TECHNICAL BULLETIN

[Issue No.] FA-A-0126

[Title] Change in the D-sub connector (RS-422) of MELSEC-A/AnS/QnA/QnAS series modules

[Relevant Models] MELSEC-A/AnS/QnA/QnAS series

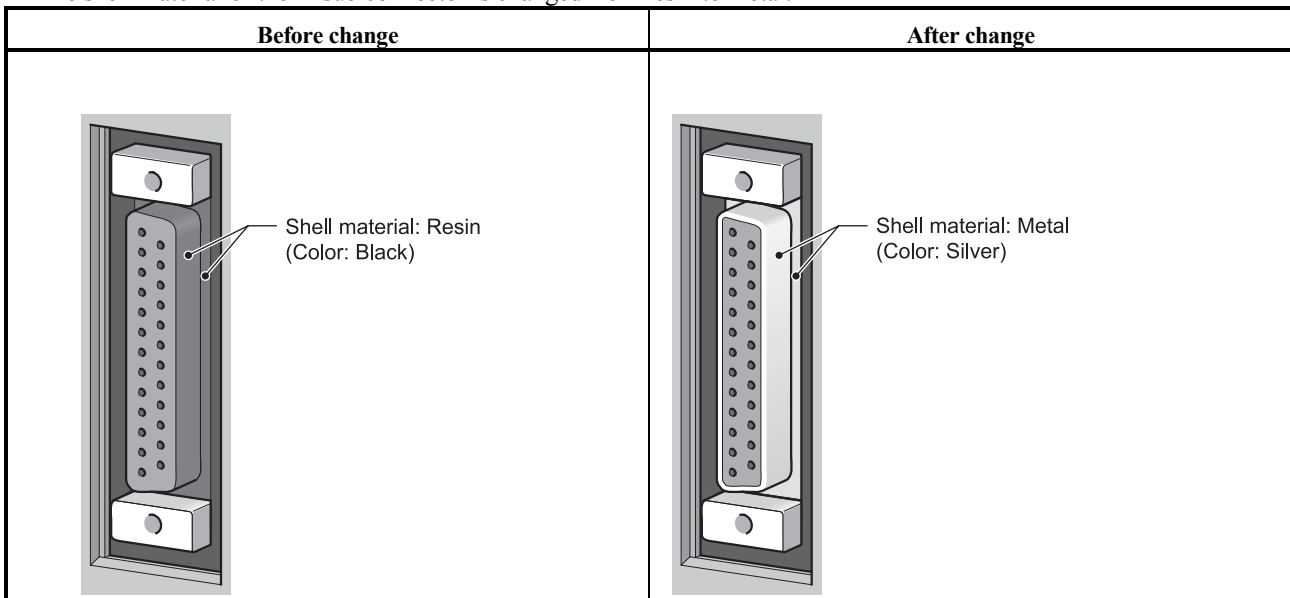
1. Change details

The shell material of the D-sub connector is changed from resin to metal.
